Modification Application
Section 4.55(1A) Modification

SSD-32275057

175-177 Cleveland Street, 1-5 and 6-8 Woodburn Street, Redfern

Prepared for Perpetual Corporate Trust Limited as trustee of Scape JV3 Eveleigh

Figure 4 Proposed Basement Plan

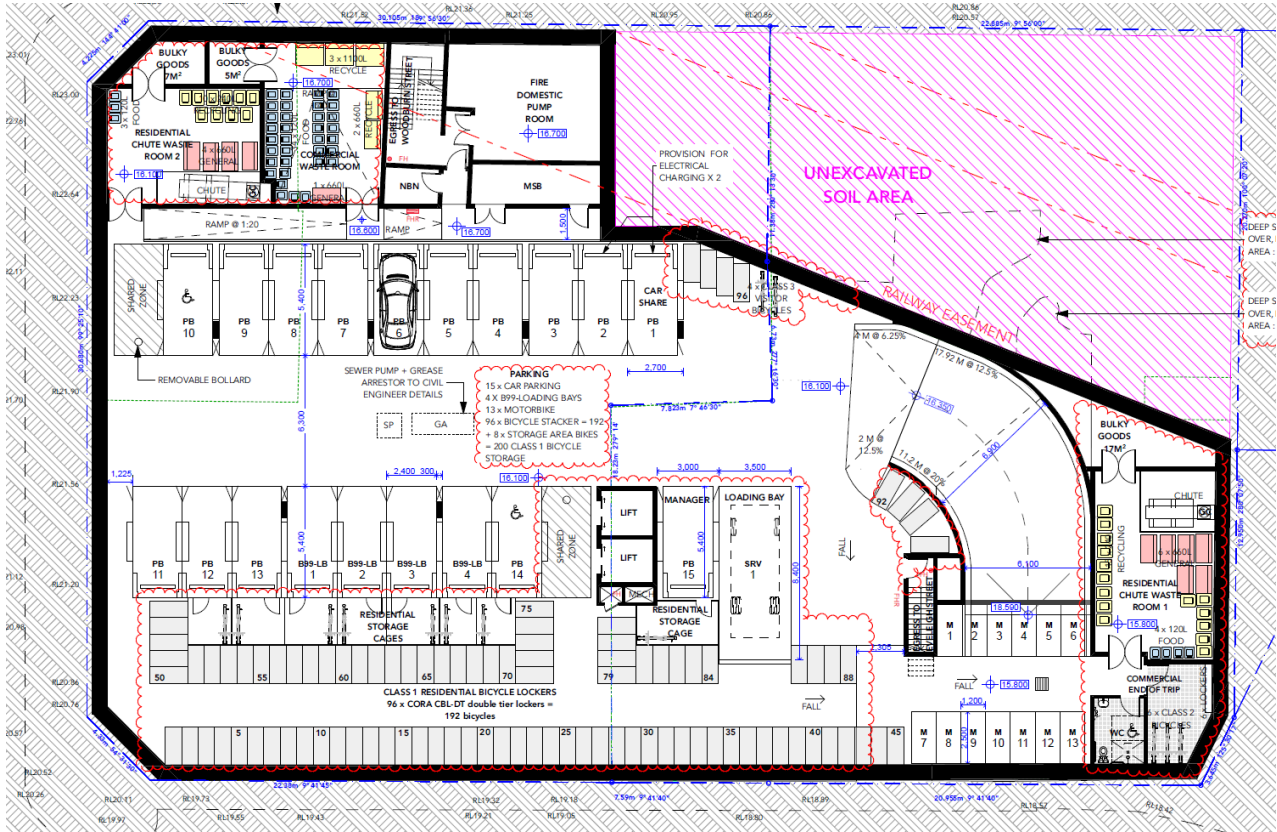
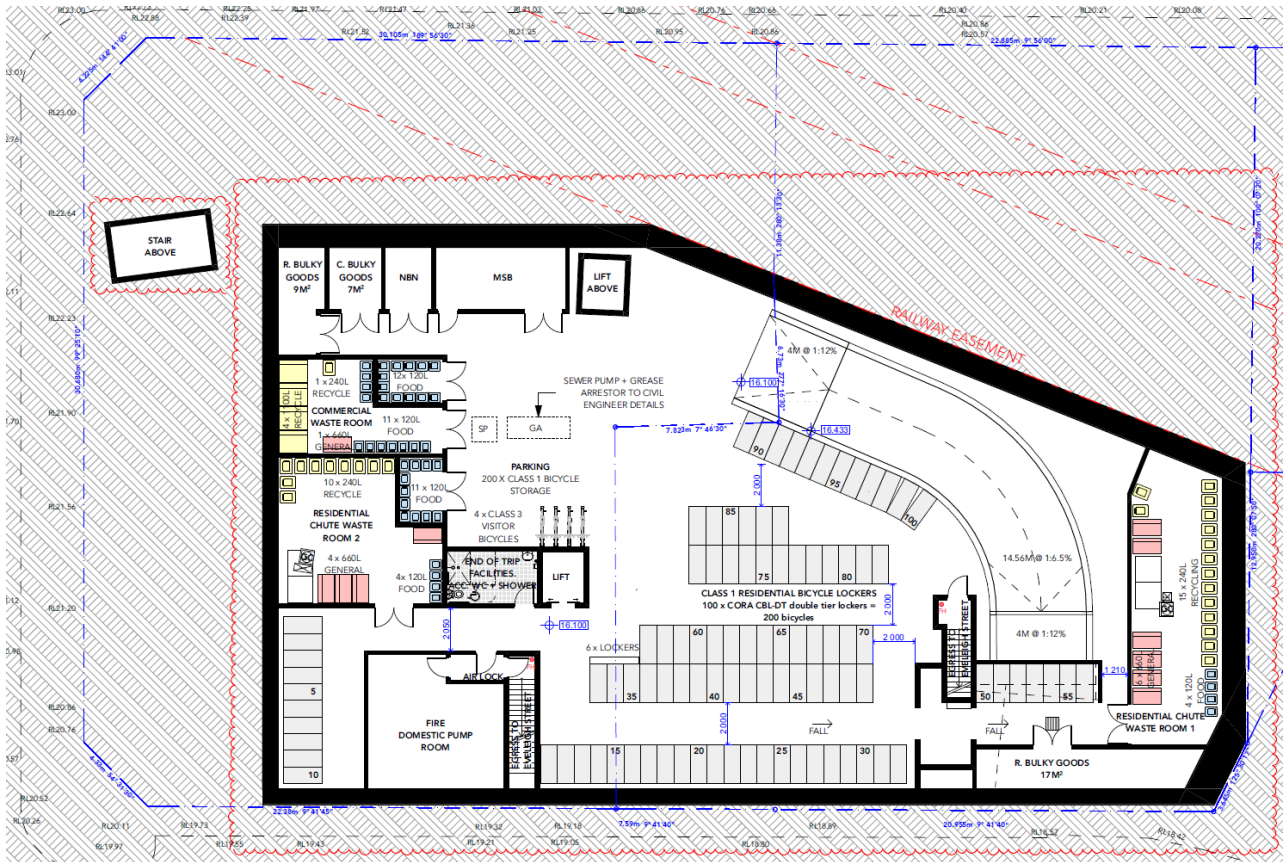
This modification application seeks to reduce the basement footprint to minimise excavation in close proximity to Cleveland Street and the adjacent railway land to the east of the site and remove any required excavation from within the zone of influence of the future proposed metro tunnel corridor. Further, the modification application removes on-site car parking for residents to minimise reliance on private vehicle ownership given the site's proximity to public transport.

The basement fire stairs are required to be relocated away from the rail corridor and zone of influence (now outside of the basement footprint) and repositioned to the western side of the basement. The basement ramp has also been adjusted to address ramping / gradient requirements (to allow for a compliant small rigid vehicle (SRV) gradient of 1:6.5), and is redesigned as a one-lane, two-way ramp proposed the non-compliant basement ramp has been proposed to be modified to comply with Australian Standards.

A number of other minor amendments are proposed to accommodate the reduced basement extent, including to the loading, servicing and waste management arrangements to ensure compliance with all relevant requirements. A comparison of the existing and proposed Basement Plan is provided in **Figure 3** and **Figure 4** below.

Figure 6 Proposed Ground Floor Plan

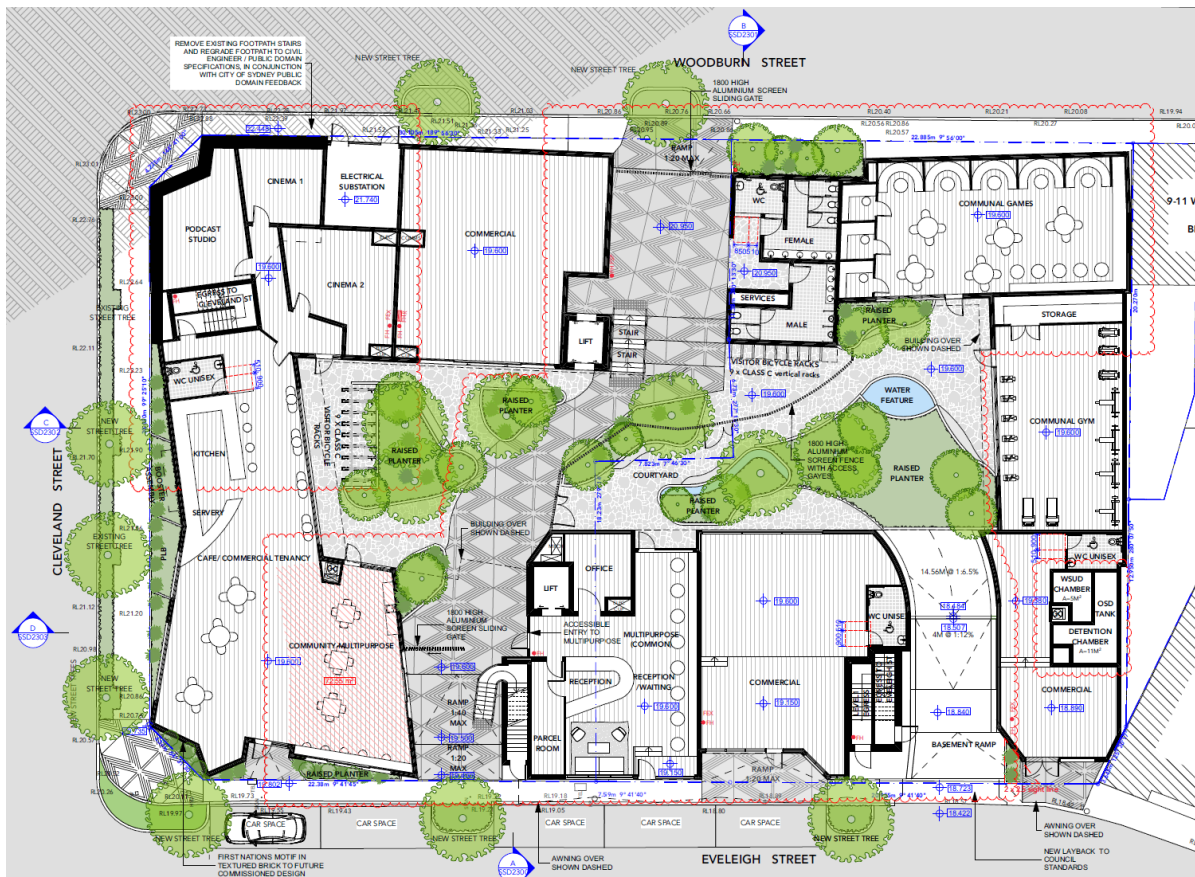
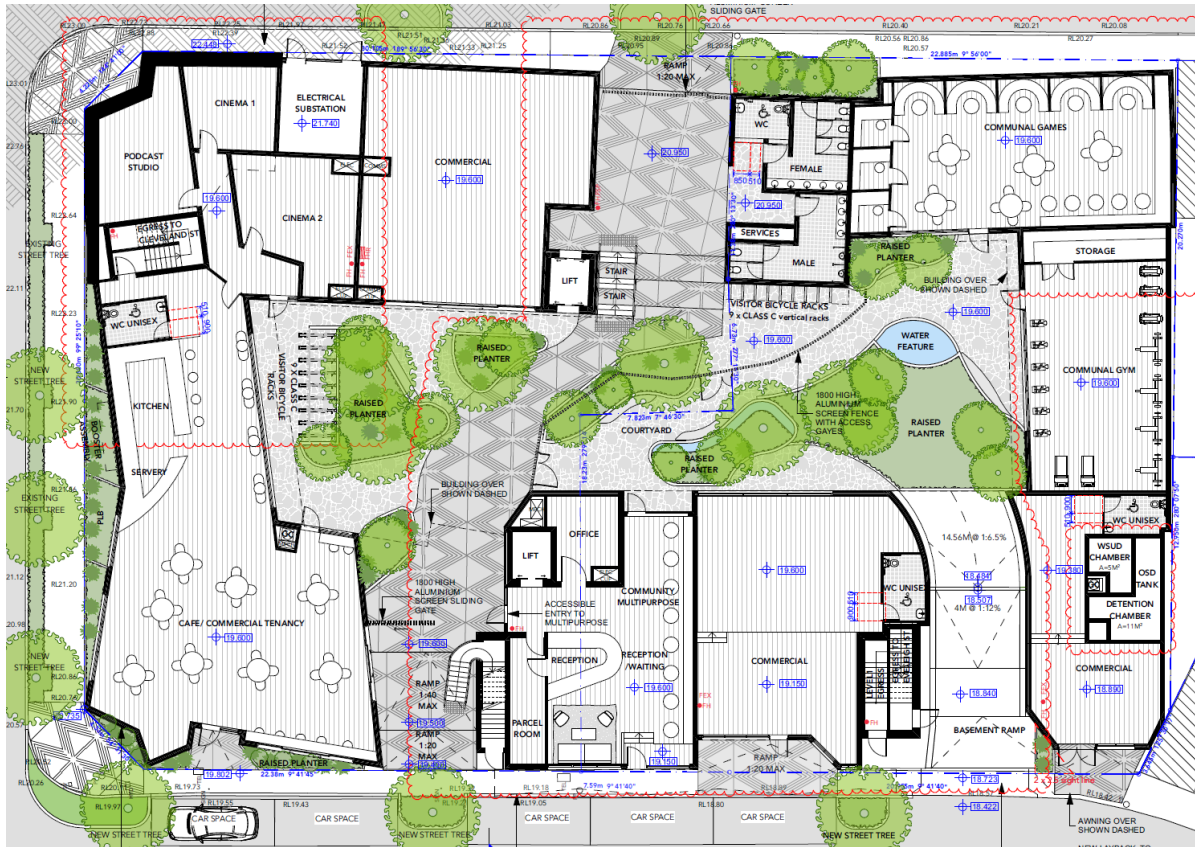
Ground floor modifications are proposed to reflect the basement changes below, and to ensure compliance with the requirements of the BCA.

- Relocation of fire stair from within the through-site link to the eastern frontage of the site.
- Minor modification to the internal space allocation, and shape of the café/commercial tenancy within the northeastern corner.

- Minor revision of ground floor landscaping including above the revised basement ramp.

Figure 5 and Figure 6 illustrates the approved and proposed Ground Floor Plan.

Figure 10 Proposed Level 5 Floor Plan

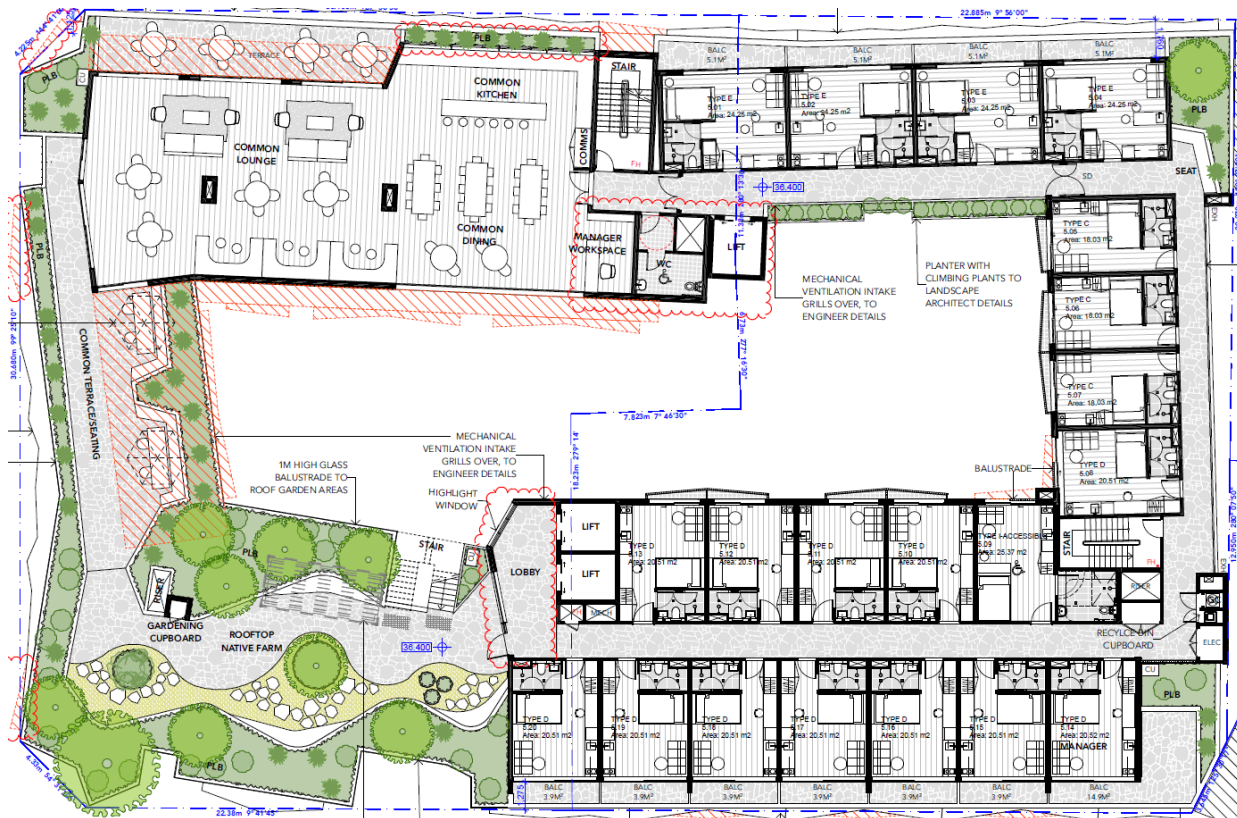
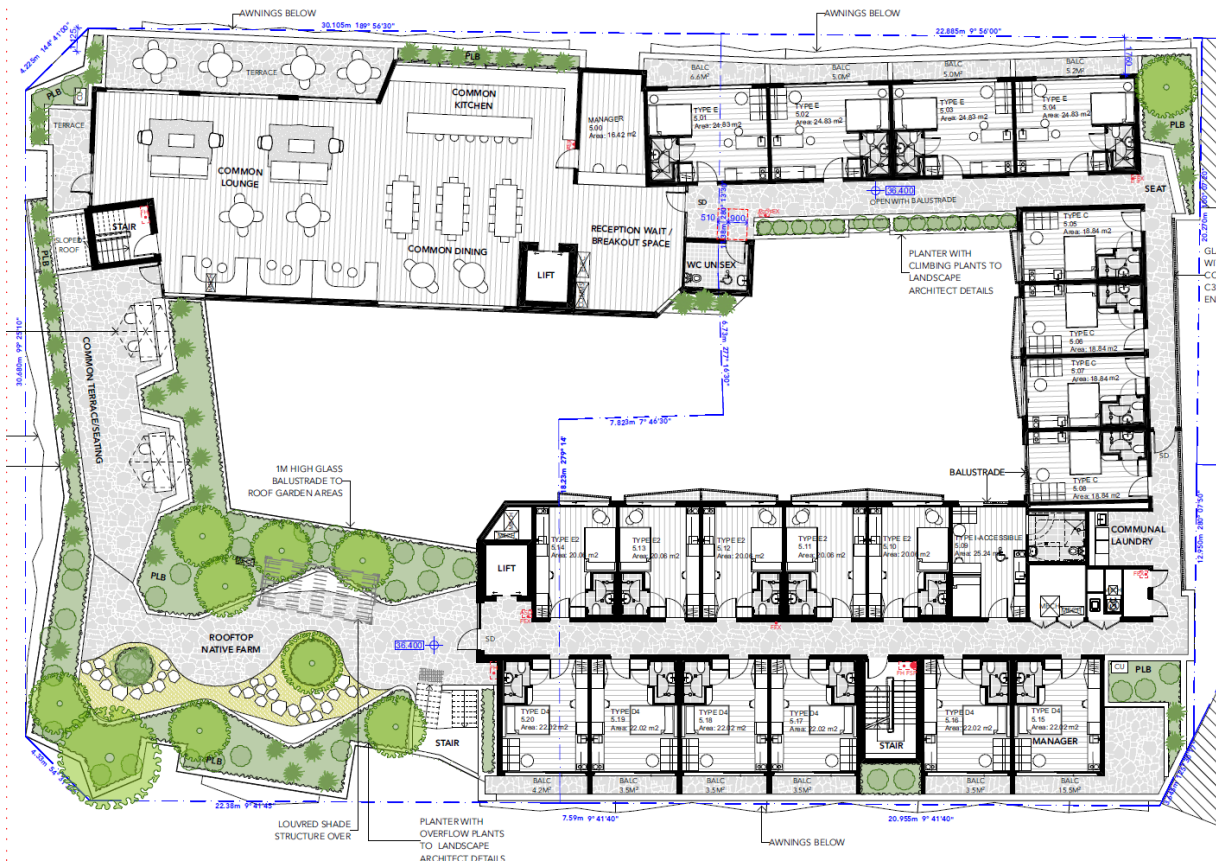
A series of minor modifications are proposed to Level 5 reflecting changes to the levels below. In addition, the common lounge area has been redesigned internally to improve the manager's workspace.

Figure 9 and **Figure 10** illustrate the differences between the approved Level 5 Floor Plan and the proposed Level 5 Floor Plan.

Figure 12 Proposed Roof Plan

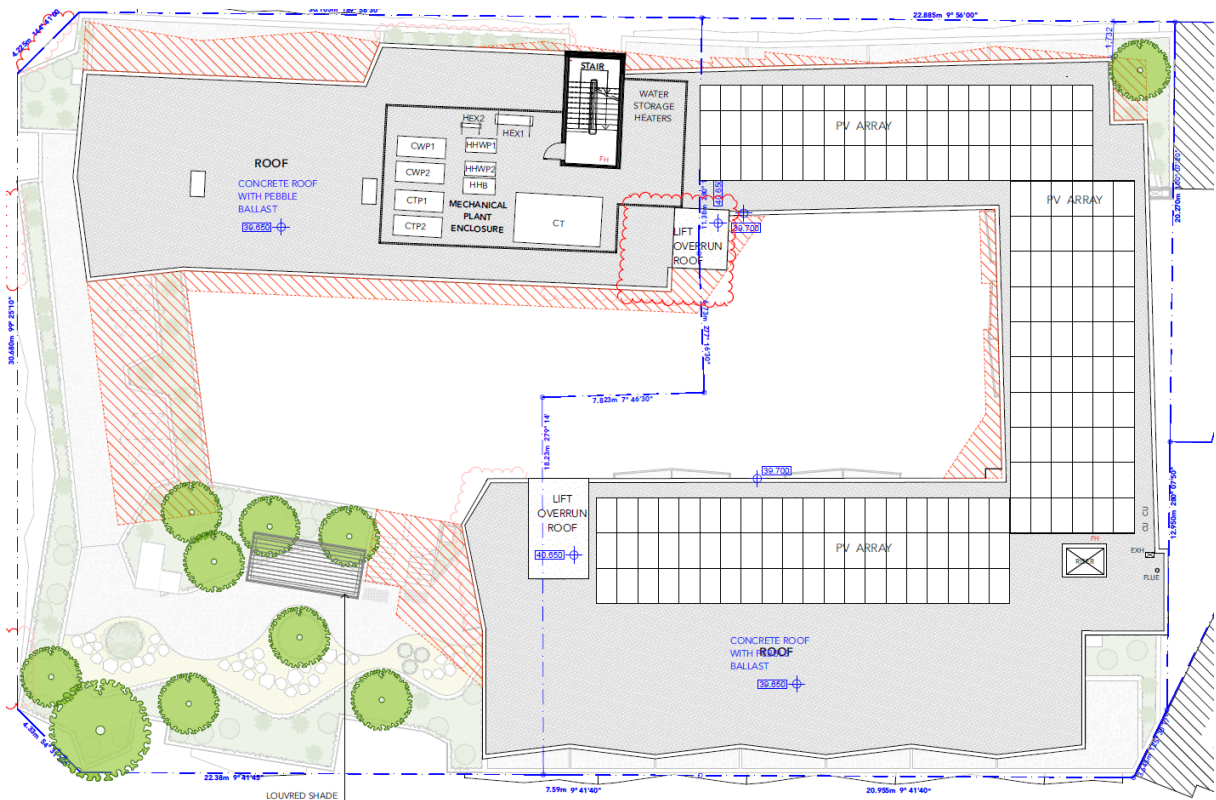
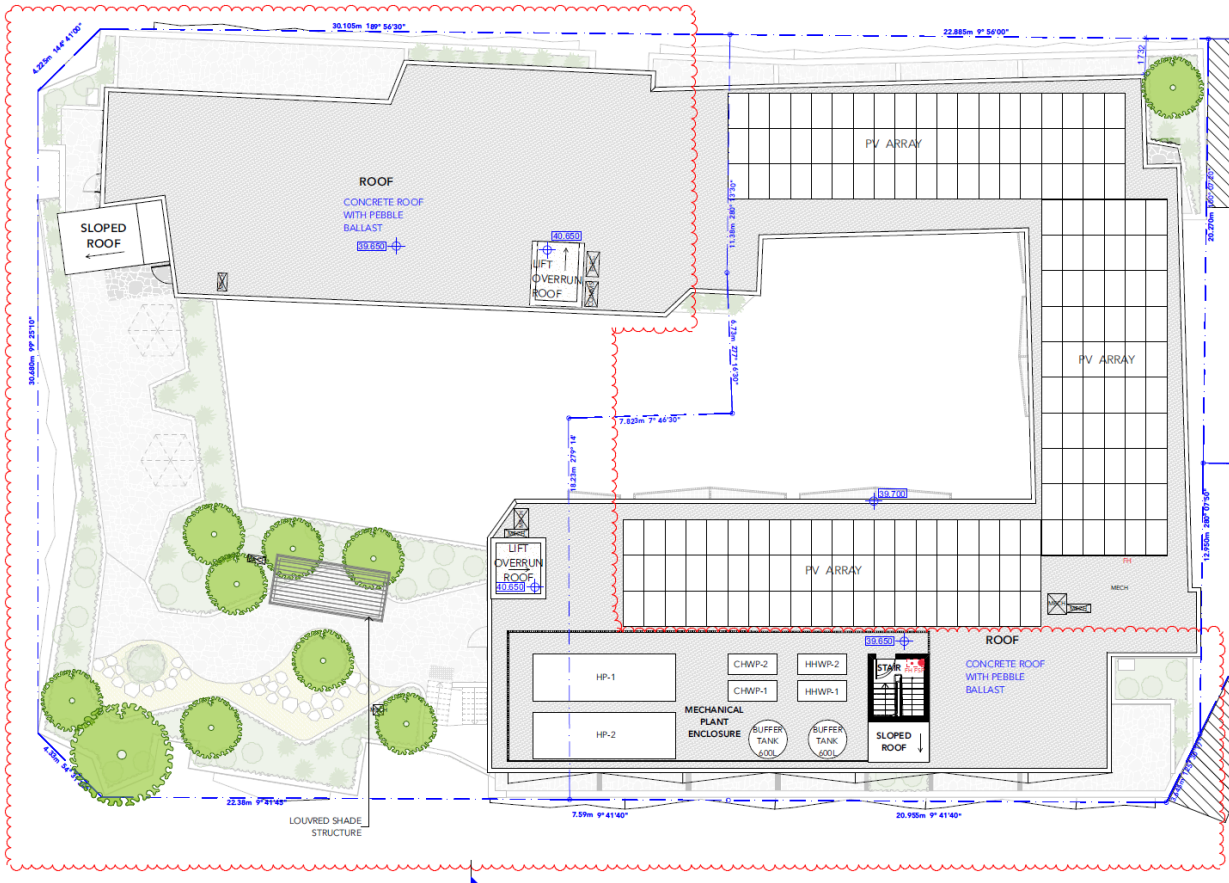
Modifications are proposed to the roof top level for consistency with the levels below. Services are proposed to be relocated, in addition to building plant enclosures, from the Woodburn Street rooftop to the Eveleigh Street rooftop. No change is proposed to the provision of photovoltaic cells upon the rooftop. The extent of modifications proposed are illustrated in Figure 11 and Figure 12 below.

Figure 14 Approved West Elevation

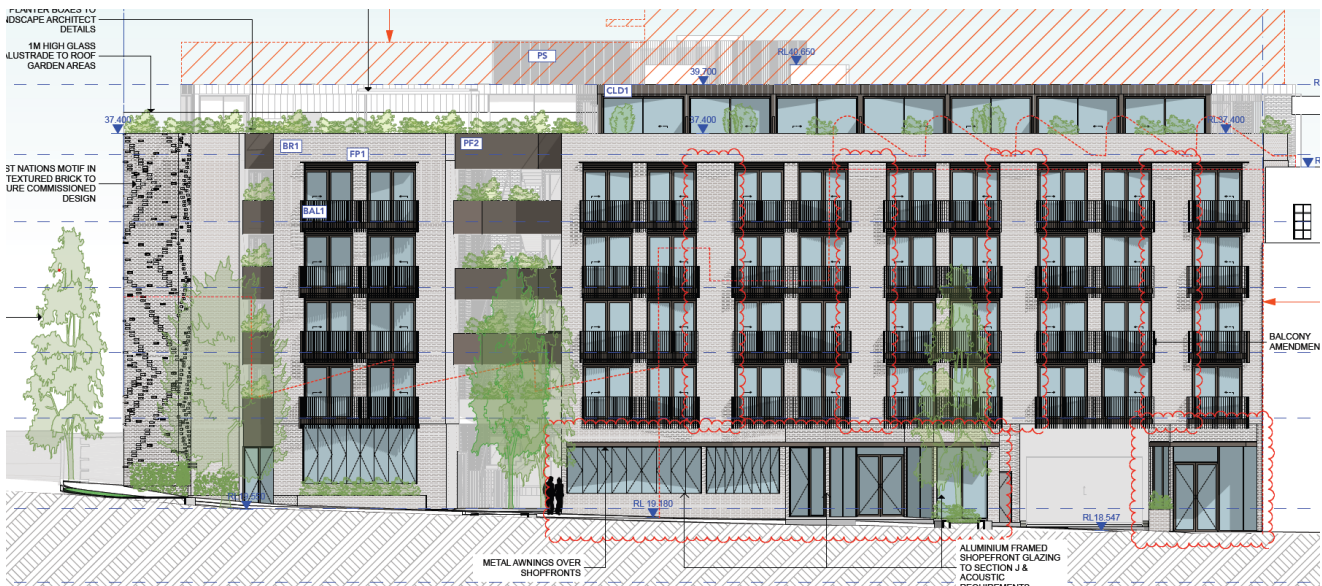
The proposed relocation of rooftop plant from the eastern extent of the building to the western extend of the building has occurred due to the redistribution of services on levels below. As a result of the proposed shift, there is no change to the maximum RL of the development, and despite the redistribution of the plant, the quantum of plant related material remains unchanged, and continues to be screened from view so the only visible element from the public domain is the screening, lift overrun and fire stair. The comparison of the approved and proposed extent of the rooftop plant when viewed from the street is illustrated upon the western elevation, as shown in **Figure 14** and **Figure 15**.

Whilst the modified rooftop plant location will result in additional visual bulk to the western elevation when viewed from the public domain, it is noted that there is a direct reduction in visual bulk to the eastern elevation when viewed from the public domain.

The proposed relocation of plant does not seek to increase the maximum RL of the building, and it is noted the maximum building height applicable to the site under the Eastern Harbour City SEPP is expressed in storeys, and the approved number of storeys is not proposed to be amended within this modification application.

Figure 16 Basement Waste Storage

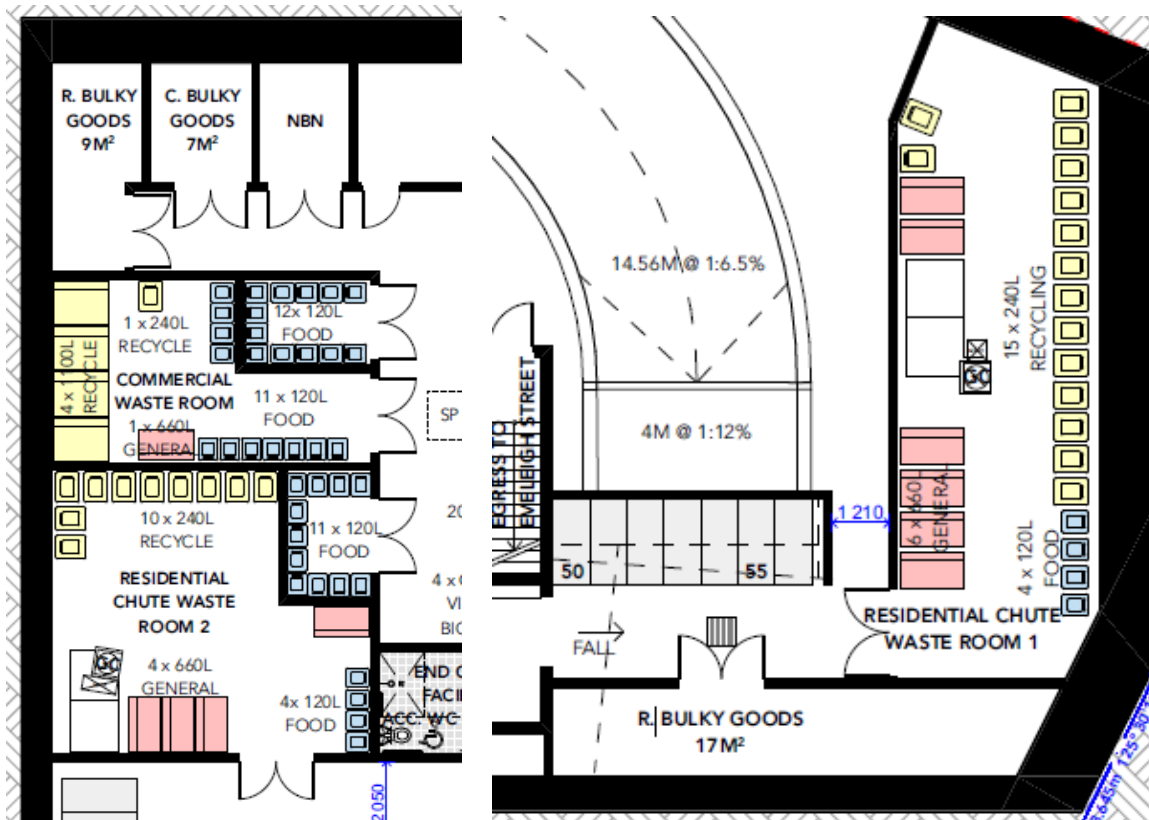
As demonstrated within the Architectural Plans, the number, and type of bins required for the development, as proposed to be modified, are able to be accommodated within the amended basement layout across a range of waste storage rooms, including 2 x residential waste rooms, 1 x commercial waste room, a residential FOGO cupboard, 2 x bulky waste rooms and 1 x commercial bulky waste room (see **Figure 16** Basement Waste Storage **Figure 16**).
